CITY OF ALBUQUERQUE

**RE: Veranda Lot 20
Lot 20 Block 2 Nassif Gardens
Grading and Drainage Plan
Engineer's Stamp Date: 01/03/2022
Hydrology File: G20D050**

DRAINAGE AND TRANSPORTATION INFORMATION SHEET (REV 6/2018)

| | GRADING AND DRAINAGE PLAN | Lot 19 Blk 2 Nassif Gardens Sub DWG |

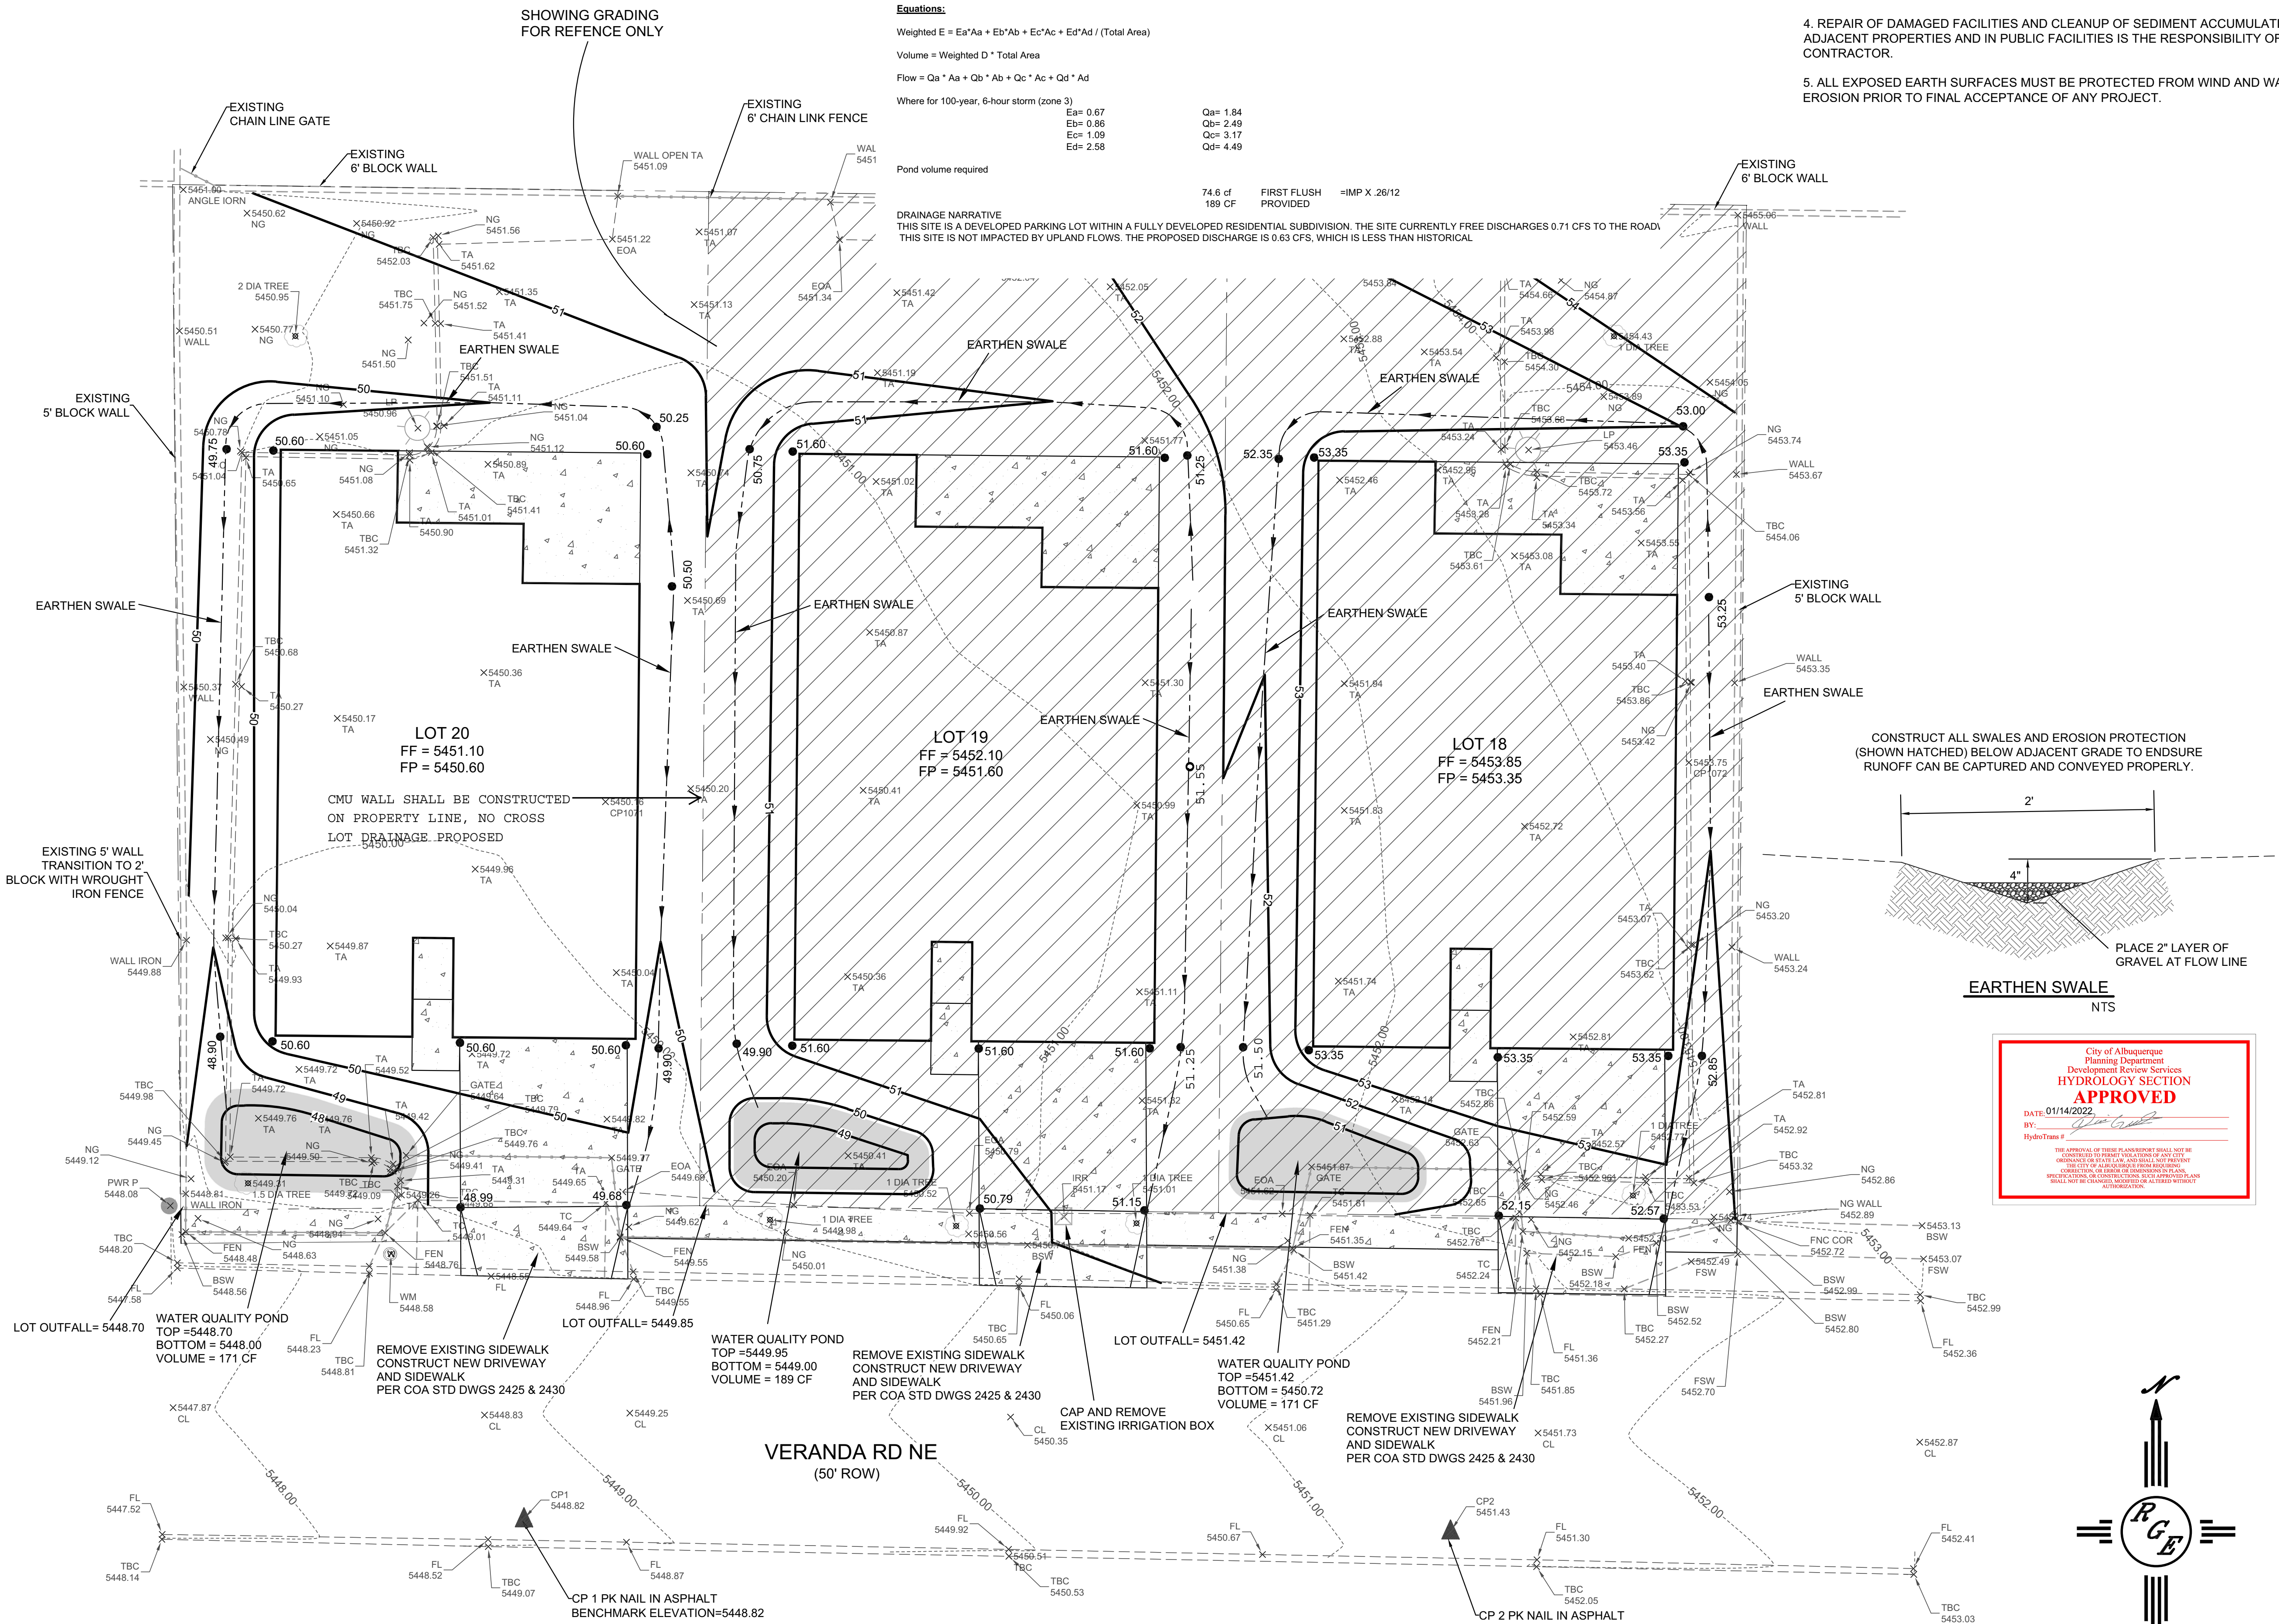
Based upon the information provided in your submittal received 01/03/2022, the Grading and Drainage Plan is approved for Building Permit and Grading Permit. Since the site has been rough graded a pad certification is not needed for this project. Please attach a copy of this approved plan in the construction sets for Building Permit processing along with a copy of this letter.

1. Engineer's Certification, per the DPM Part 6-14 (F): Engineer's Certification Checklist For Non-Subdivision is required.
